MUNICIPAL REVISE PERMIT AND INSPECTION RECORD

Municipal #: **2026001961**
Process Number: M2025015205
Issue Date:
Revision Process Number: M2026008532

Application Type: NEW
Proposed Use: PARKING GARAGE/OPEN DECK
Sq. Ft.: 468377 / Units: 0 / Floors: 0
Permit Type: MUNICIPAL BLDG / Permit Category: 0001 MUNICIPAL GENERAL BUILDING

VEHICLE STORAGE
16100 NW 59 Ave.
Miami Lakes, FL 33014

GROUND LEVEL PLAN

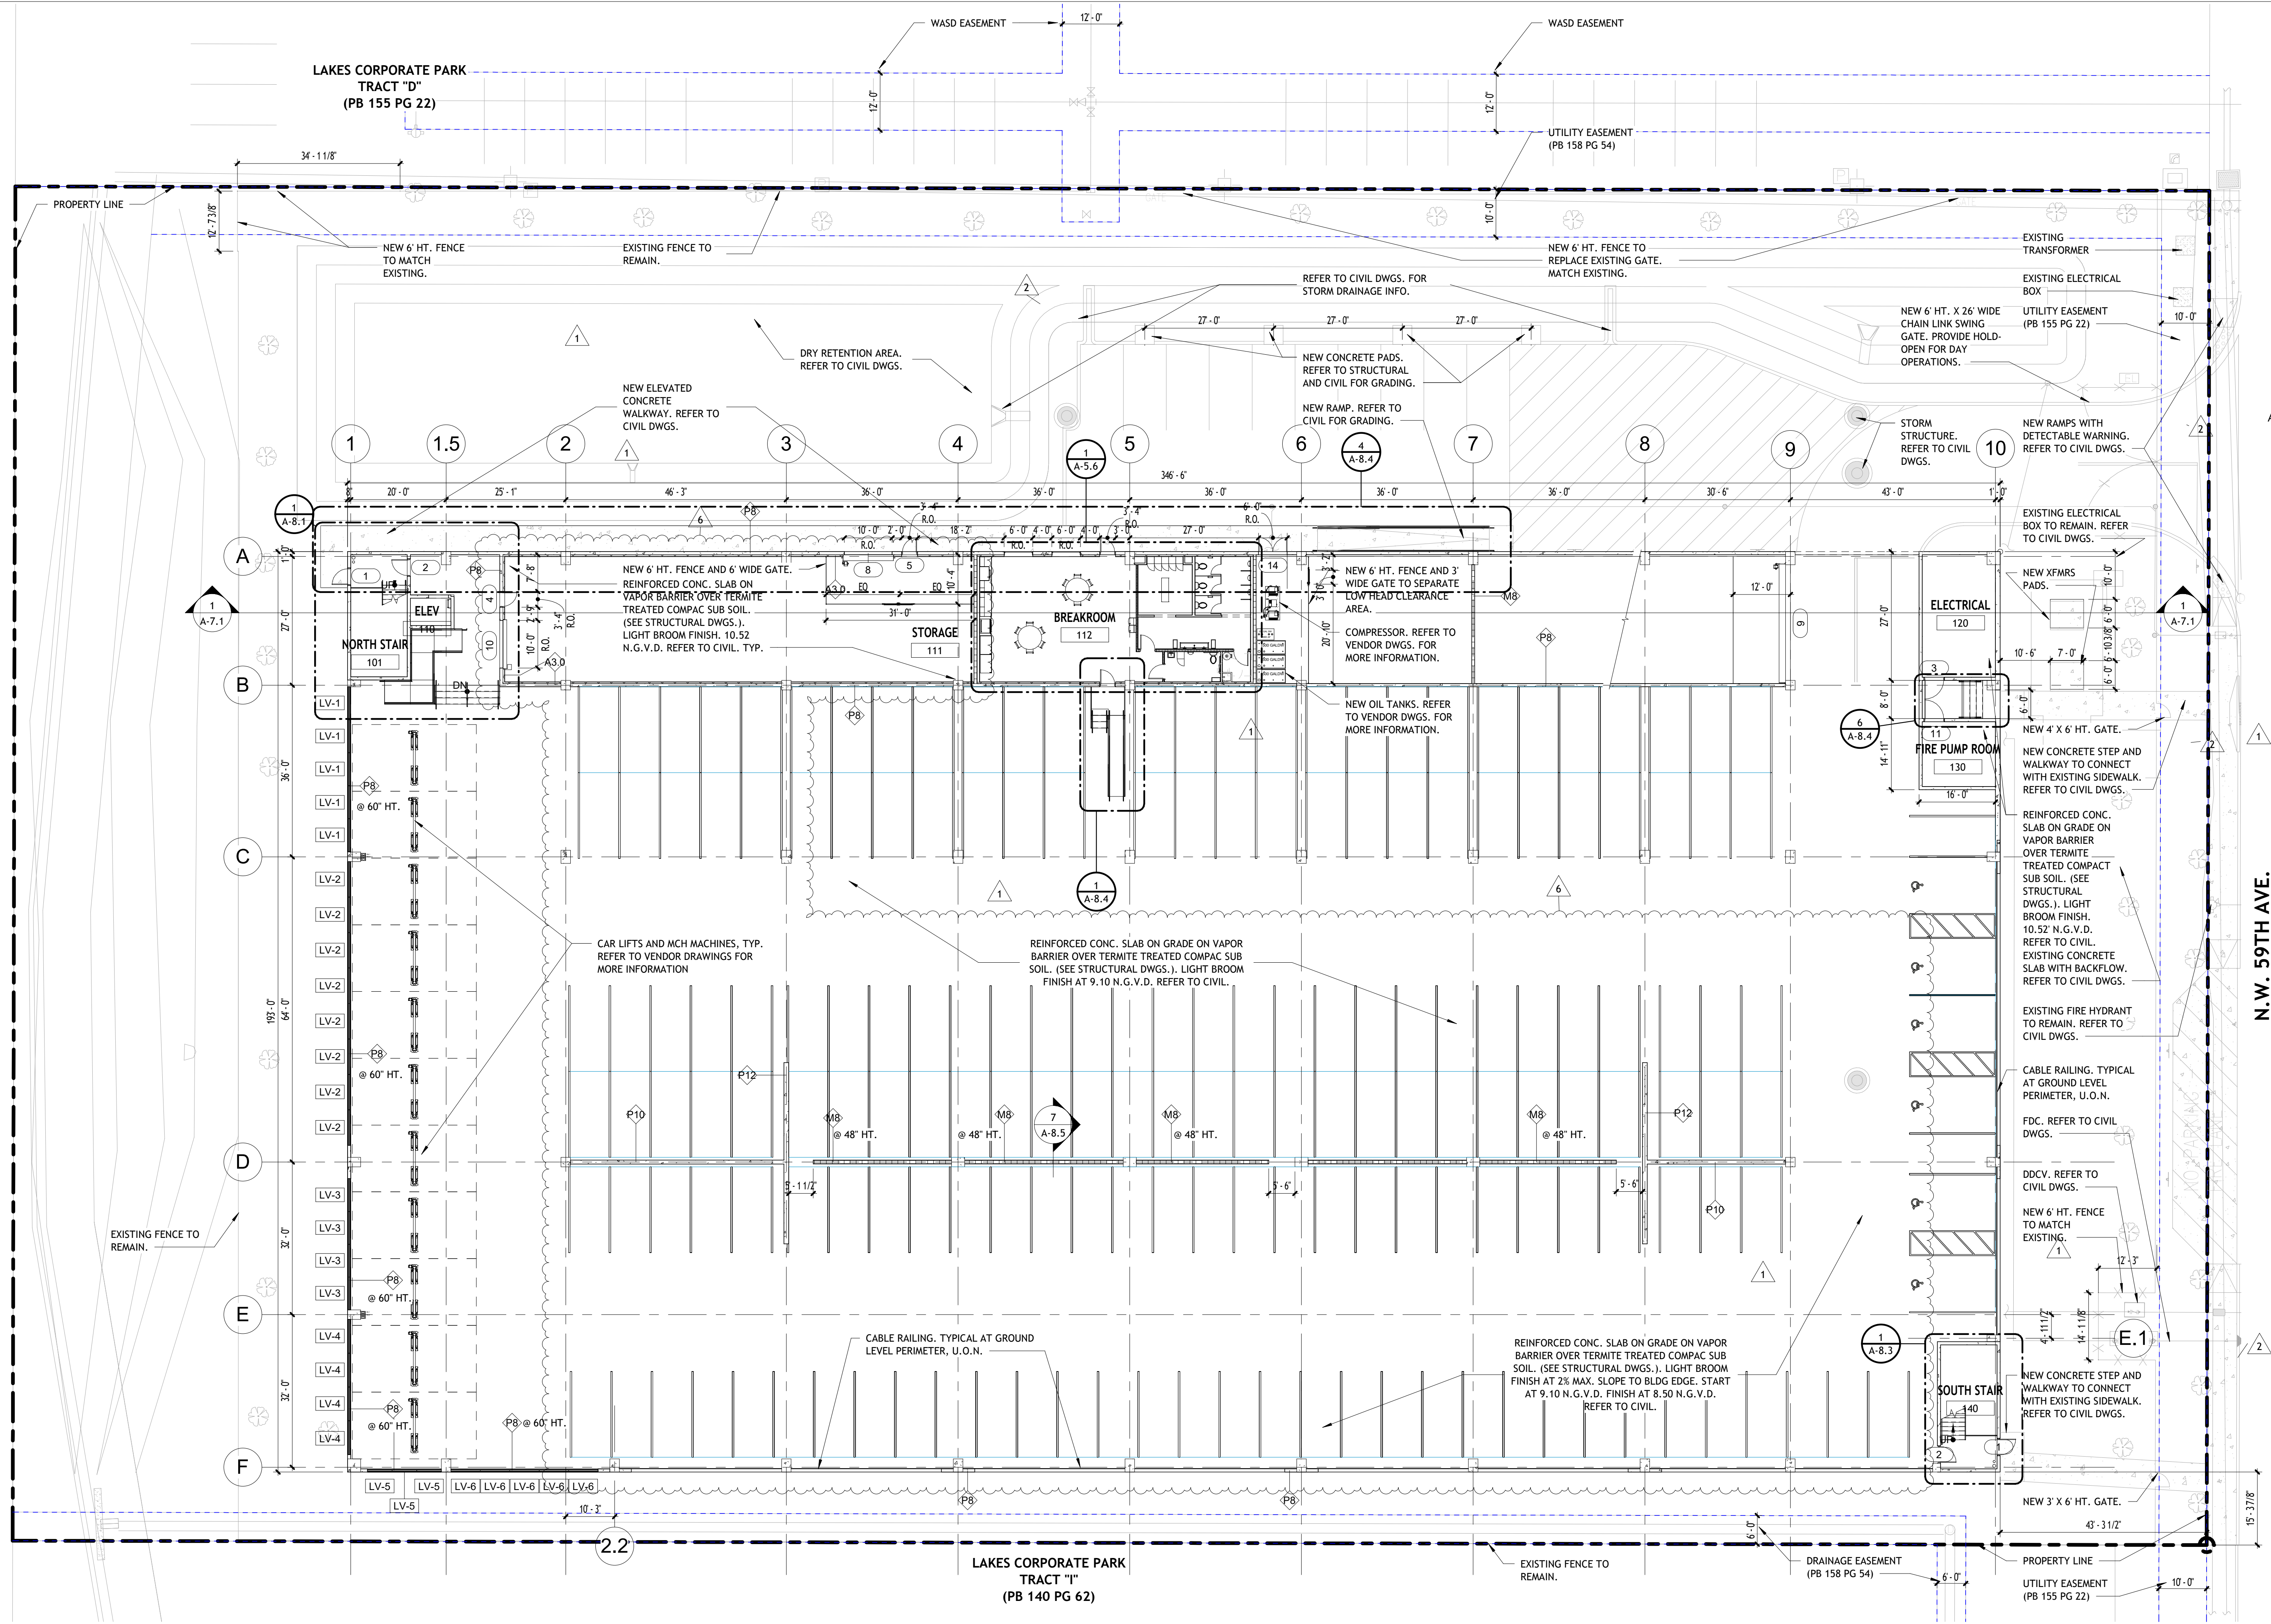
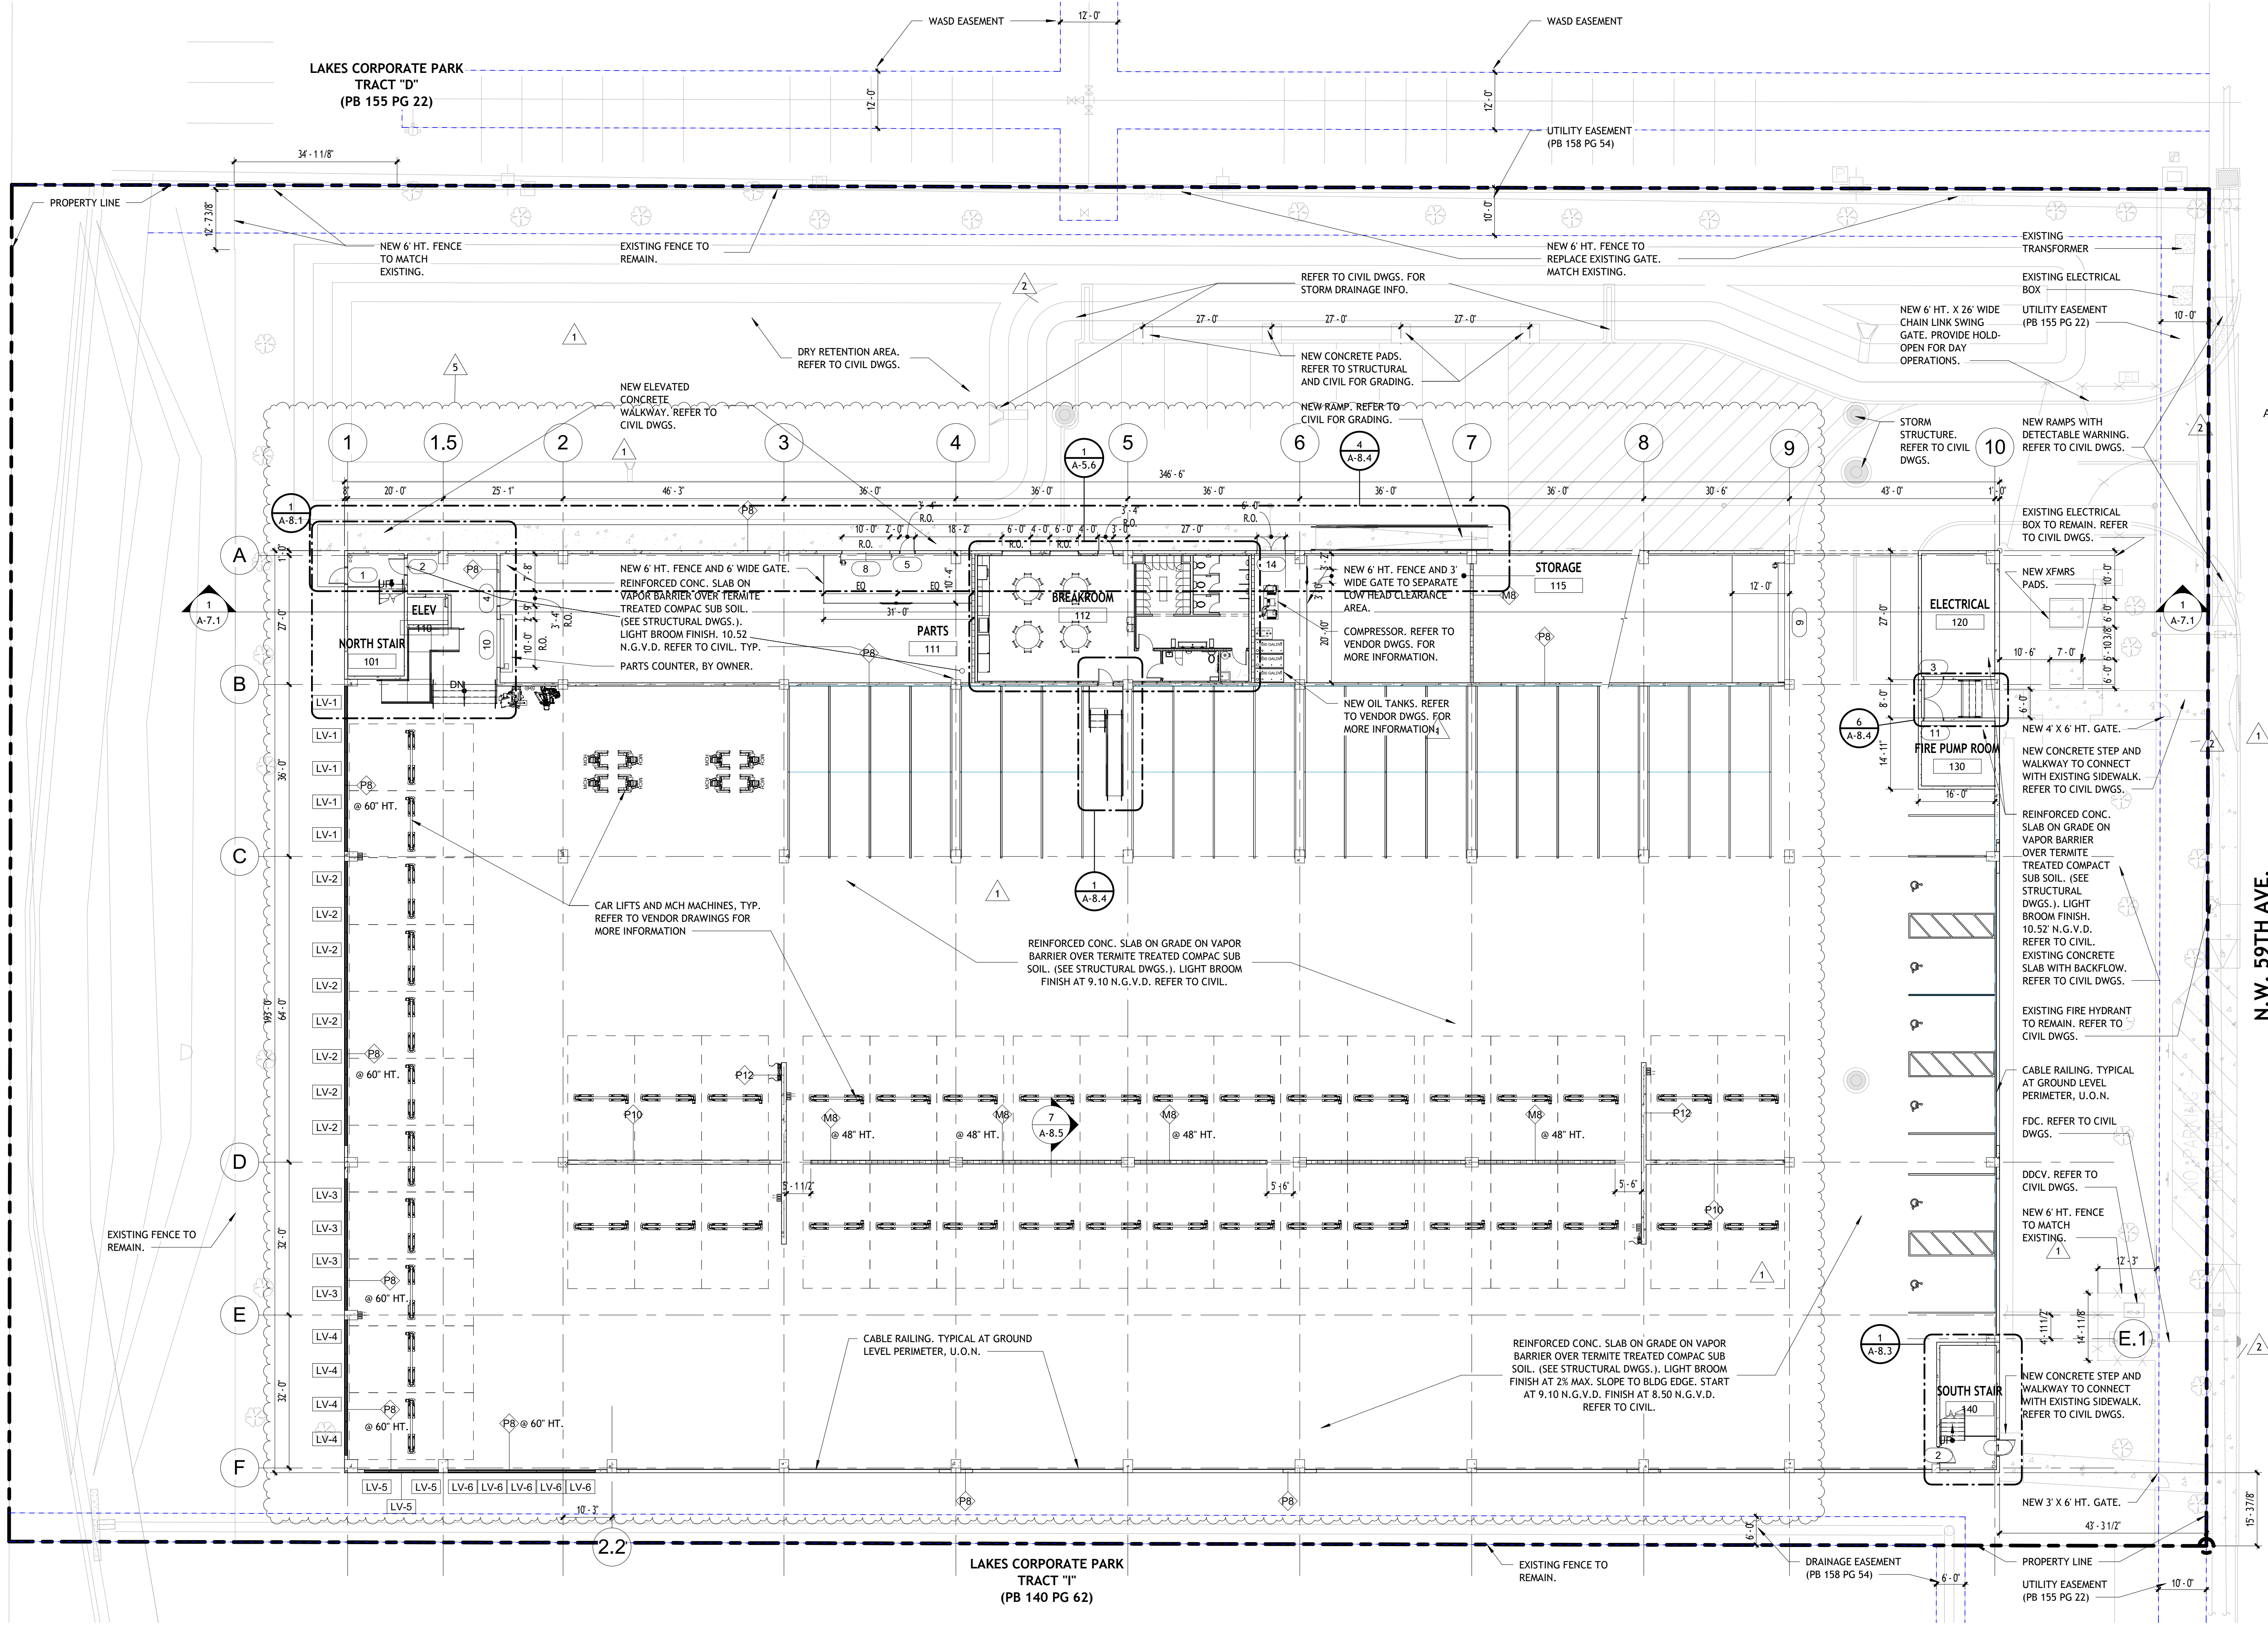
1. Previous approval granted strictly for vehicle storage only, there shall be no truck maintenance/repair no vehicle washing, no vehicle dismantling, no vehicle painting, no work on vehicle whatsoever and no liquid waste generation, dispose of, discharge or store within the property other than domestic sewer without previous DERM written approval. Sheet A-2.1 shows car lift, mechanical machines and oil tanks.

7. Sheet A-2.1 shows car lift and mechanical machines. Therefore, list on plans all unused automobile fluids to be used at the maintenance being permitted, e.g. oils, antifreeze, ATF, etc. Call on plans for the size of the containers in gallon, for each material listed and stored on site. Provide details on plans and modify accordingly.

8. Sheet A-2.1 shows four (4) oil tanks. Therefore, show on plans a detail of the above ground storage tank (AST) being installed and all of its components (i.e. valve, fuel gauge, overspill containment box, etc.) it might need different views of the AST. No cut sheets will be accepted.

RESPONSE: The scope of this project has been modified from vehicle storage only to include limited light vehicle maintenance operations, as indicated on Sheet A-2.1. As such, this submittal is intended to obtain the necessary approvals for this updated use.

RESPONSE: A dedicated AST detail will be added to the drawings, including:
